**DEVIATION REQUEST** (Attach diagrams, figures, and other documentation to clarify request)

A deviation from the standards of or in Section **2.2.4.B.2** of the Engineering Criteria Manual (ECM) is requested.

This request is to allow lane width of 10 feet in each direction on a private local low volume residential roadway where 12 feet is required by the ECM.

**PRIVATE ROAD SECTION (PROMISE POINT)**

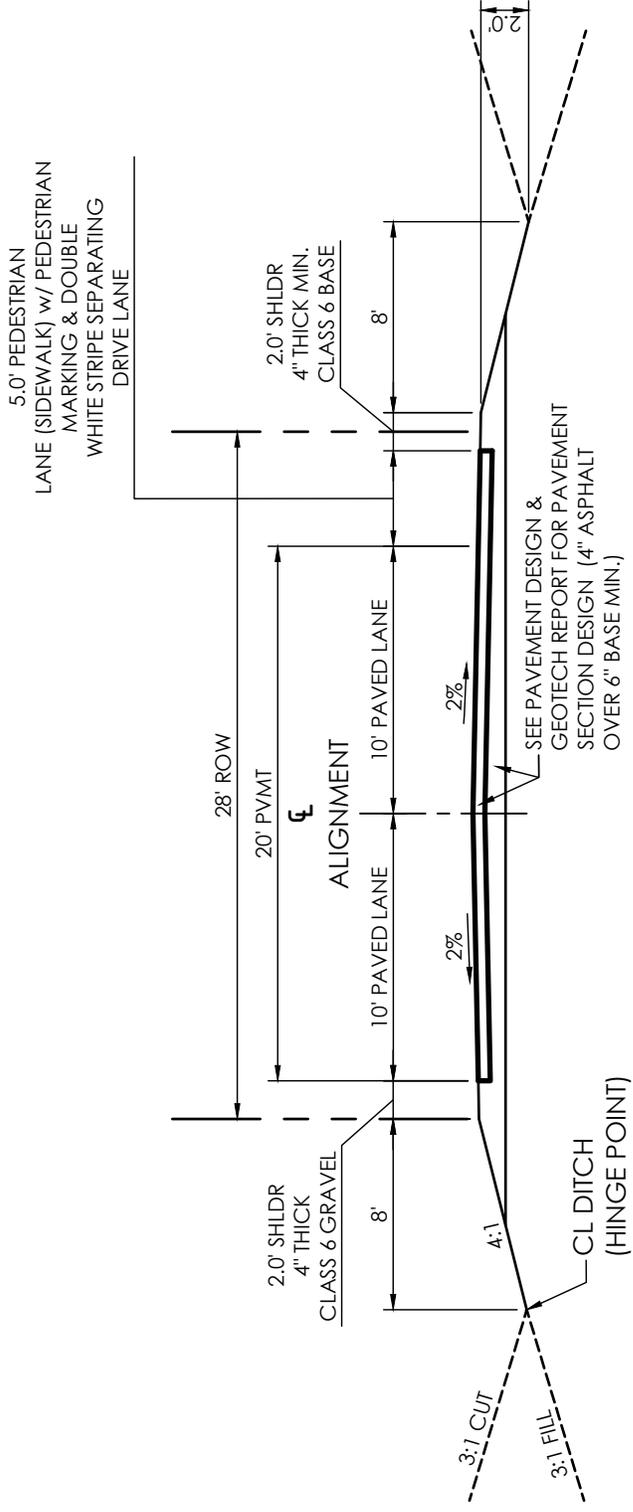
The proposal is to allow a private local low-volume roadway with one ten-foot wide travel lane in each direction. The ECM provides for 12' wide lanes for all roadway classifications. Ten-foot lanes are adequate to allow two passenger vehicles or pickup trucks to pass each other while remaining within the lanes. Narrower lanes are allowed in instances of limited right-of-way or topographical restrictions.

This request has been determined to have met the criteria for approval. A deviation from Section 2.2.4.B.2 of the ECM is hereby granted based on the justification provided.
